Dominion Energy Nuclear Connecticut, Inc.
5000 Dominion Boulevard, Glen Allen, VA 23060
DominionEnergy.com

May 3, 2018

DOMINION ENERGY NUCLEAR CONNECTICUT, INC.
MILLSTONE POWER STATION UNIT 3
LICENSE AMENDMENT REQUEST REGARDING PROPOSED TECHNICAL
SPECIFICATIONS CHANGES FOR SPENT FUEL STORAGE AND NEW FUEL STORAGE

Figure 3.9-5 Minimum Fuel Assembly Burnup and Decay Time Versus Nominal Initial Enrichment for Region 3 Storage Configuration for Assemblies from Post-Uprate (3650 Mwt) Cores

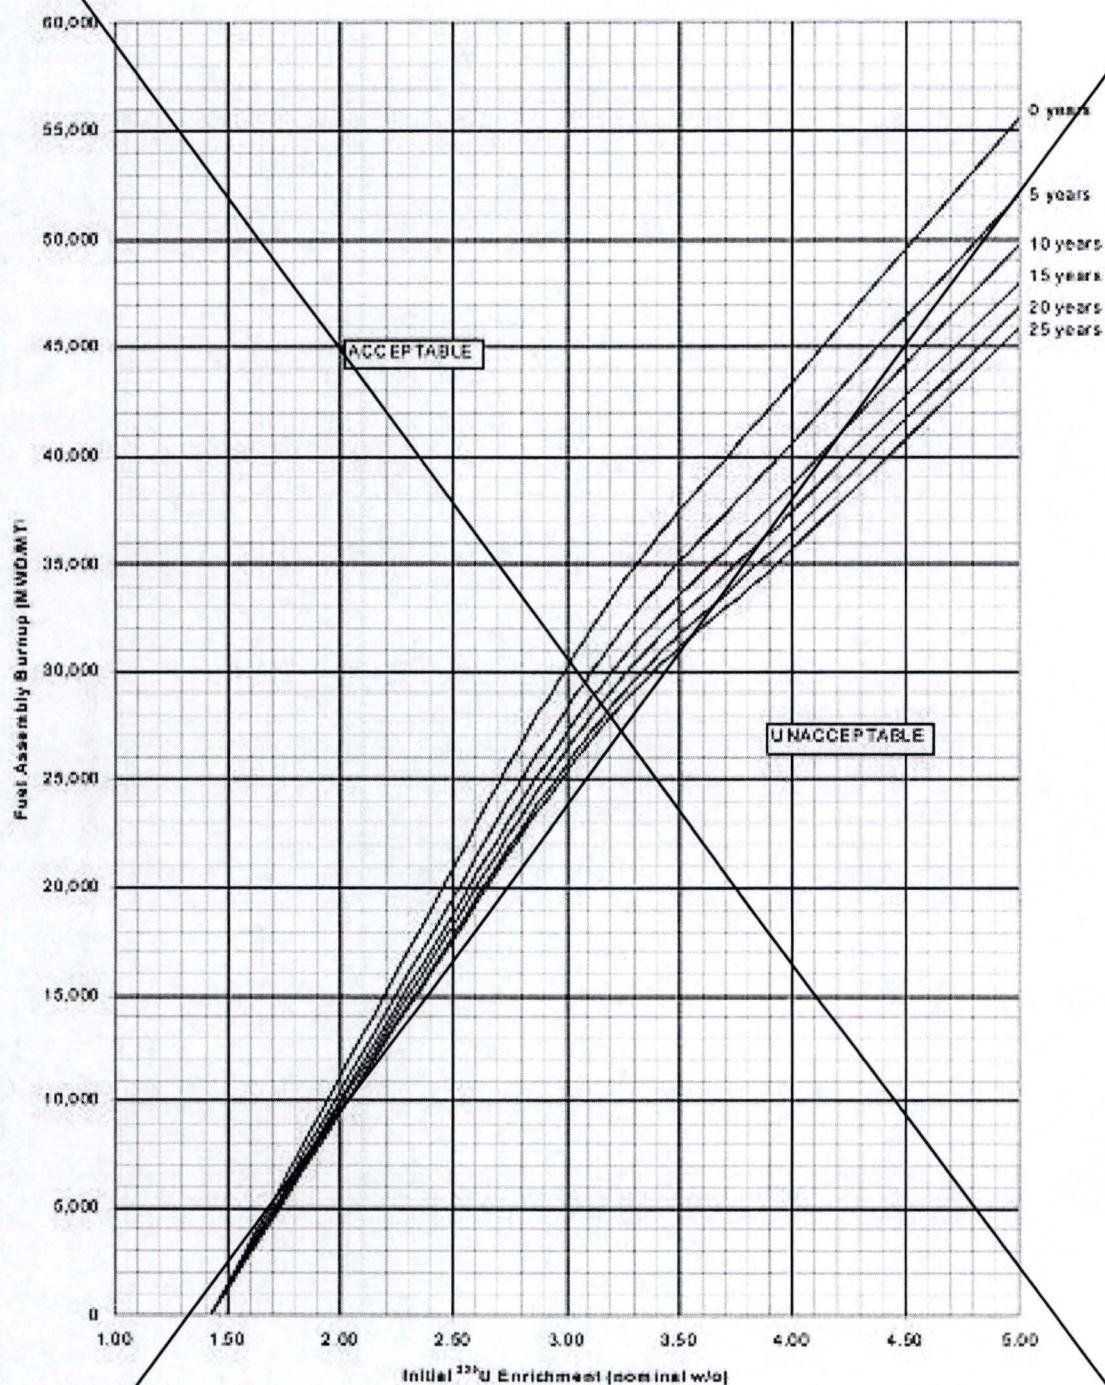
TS Figure 3.9-5

TS Figure 3.9-5 is deleted.
